Comment on amt-2022-61 from Anonymous Referee #2

This paper describes a method to estimate the 3D cloud envelope and development velocity using simulated images of a triplet of small satellites in a sun-synchronous orbit at 600 km height. The focus lies on trade wind cumulus and deep convection, while the methodology relies on stereo analysis and tracking to compute the 3D points of the cloud envelope and subsequent cloud motion estimation. The study assesses the feasibility and accuracy of the proposed mission design.

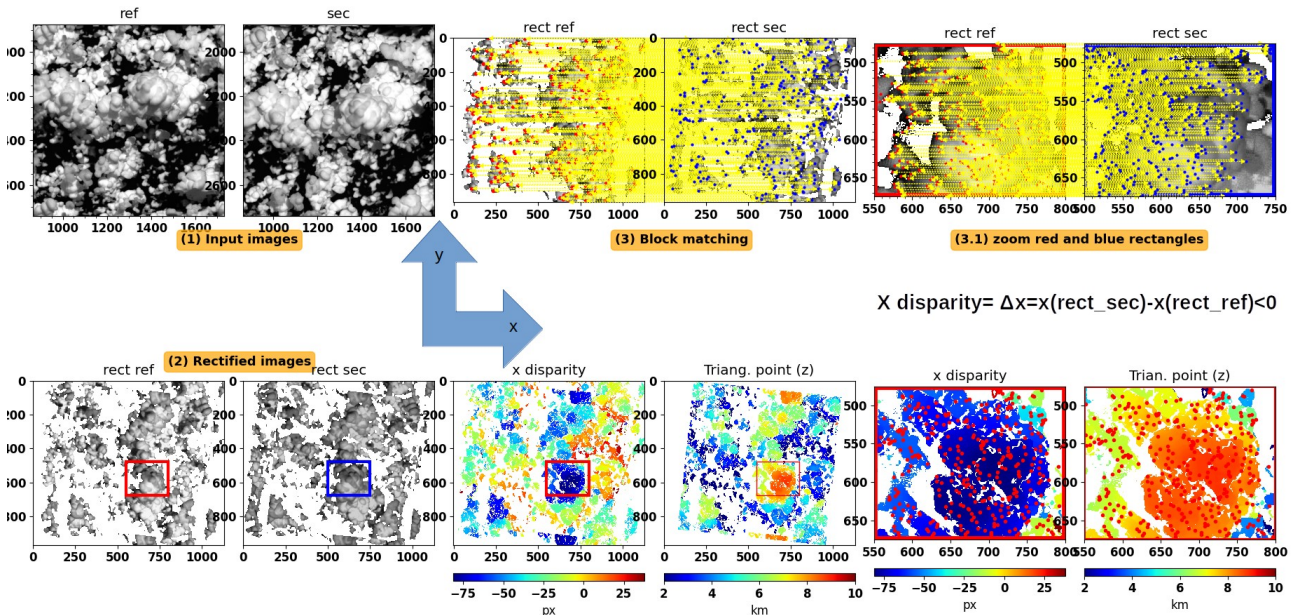
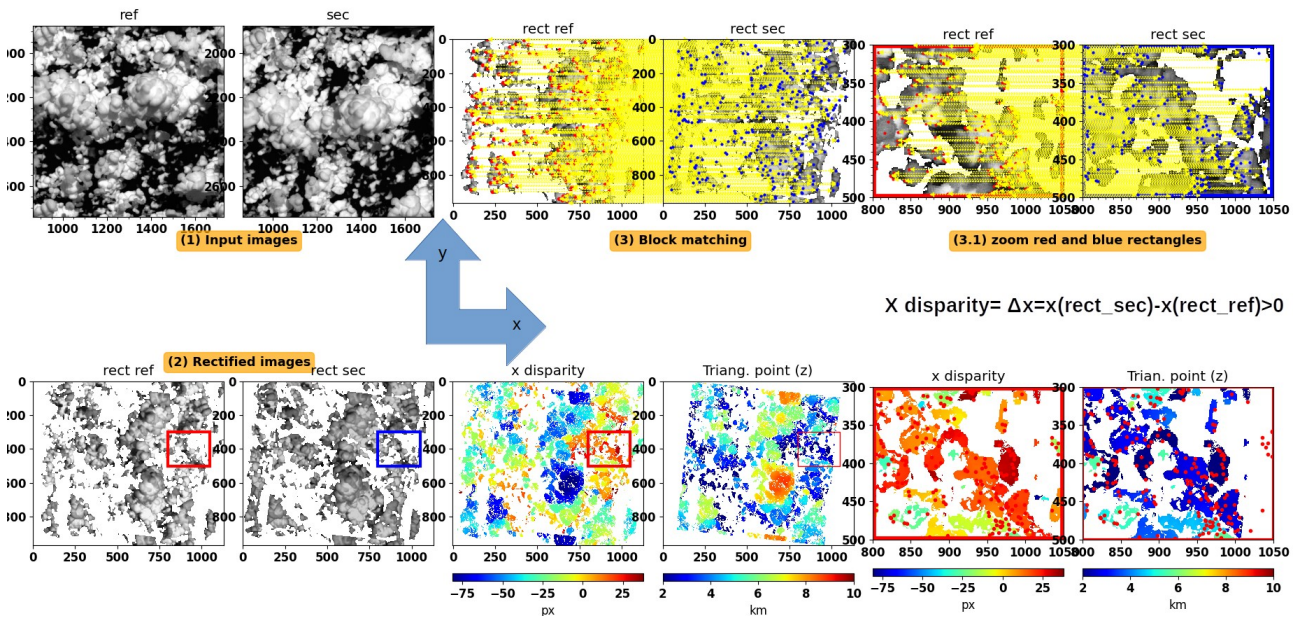
8. Line 279 / Fig. 8:

You describe that you conduct a stereo image rectification in order to make the stereo analysis easier, aren't you? In that case the y-component is usually zero (which you write in line 285). Is that correct? Also the disparity (parallax) should have values between 0 and infinity (or negative). But in Fig. disparities are both negative and positive. A negative disparity would mean that the observed point is behind the cameras. Or do I miss something?

Image rectification is indeed done to make the search of matching features easier. In this way matching cloud pixels are found on the same horizontal lines ( $\Delta y = \text{vertical disparity} = 0$ ). Vertical disparity is 0 as this is the main purpose of rectification. If this was not the case this would introduce an "epipolar" error that would affect the performance of the stereo matching. Once the images are rectified the only disparity that we are left with is the disparity along the x axis. This is measured, for each pair of matching features with image coordinates (h, k), in the rectified reference image, and (h+ $\Delta x$ , k), in the rectified secondary image, as  $X \text{ disparity} = \Delta x = x(\text{rect\_sec}) - x(\text{rect\_ref})$ .

Following are two examples of negative and positive disparity, respectively.

In this case disparity is negative as for any given pair of matching features it turns out that  $x_{rec\ sec} < x_{rec\ ref}$  (see x values for matching cloud structures).

In this case disparity is positive as for any given pair of matching features it turns out that  $x_{rec\ sec} > x_{rec\ ref}$  (see x values for matching cloud structures).

## Stereo Points $\text{abs}(V_z) > 20 \text{m/s}$

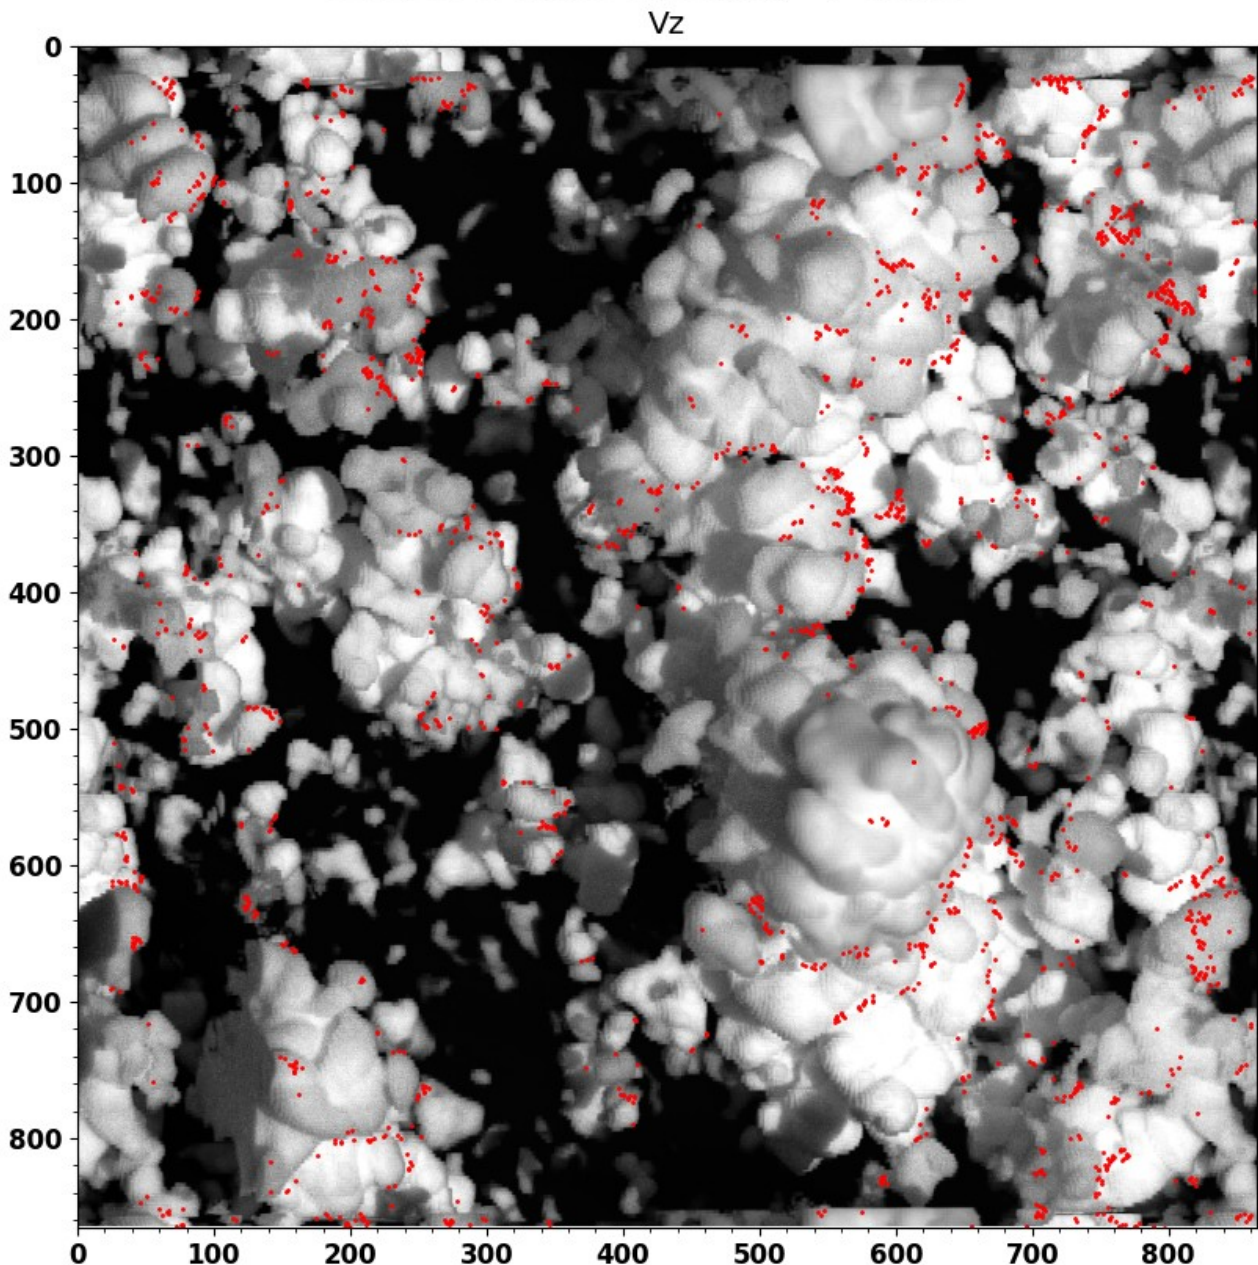
11. Fig. 12:

A sigma of 22.85 m/s in Fig. 12a for  $V_z$  seems a bit large considering the histogram.

Thanks for this remark. That is correct. By redoing the calculations we found out that about 2% of the total stereo retrieved points, those shown in red in the following figure,

are associated to unrealistically high values of  $V_z$  with  $\text{abs}(V_z) > 20 \text{m/s}$ . As it can be seen these points are mostly located over the cloud edges or in shaded regions where stereo reconstruction is expected to be less accurate. We therefore screen out these points and by redoing the calculations we now find a sigma of about 5.1 m/s , 1.1 m/s and 6.8 m/s for z, x and y, respectively and mean values of about 1.6 m/s, 6.4 m/s and 5.9 m/s for z, x and y, respectively.

For consistency with these changes, we redo Fig. 12a, extend the range of values, for the x axis of the  $V_z$  histogram, up to 20 m/s and also update (line 408-410, pp.28) (lines 461, 462 – pp. 30 in the revised manuscript) the following phrase:

“It should be noticed that about 2% of the total number of stereo retrieved points, mostly located over the cloud edges or in shaded regions where stereo reconstruction is expected to be less accurate, are associated to unrealistically high values of  $V_z$  with  $\text{abs}(V_z) > 20$  m/s. Such points were filtered out.”
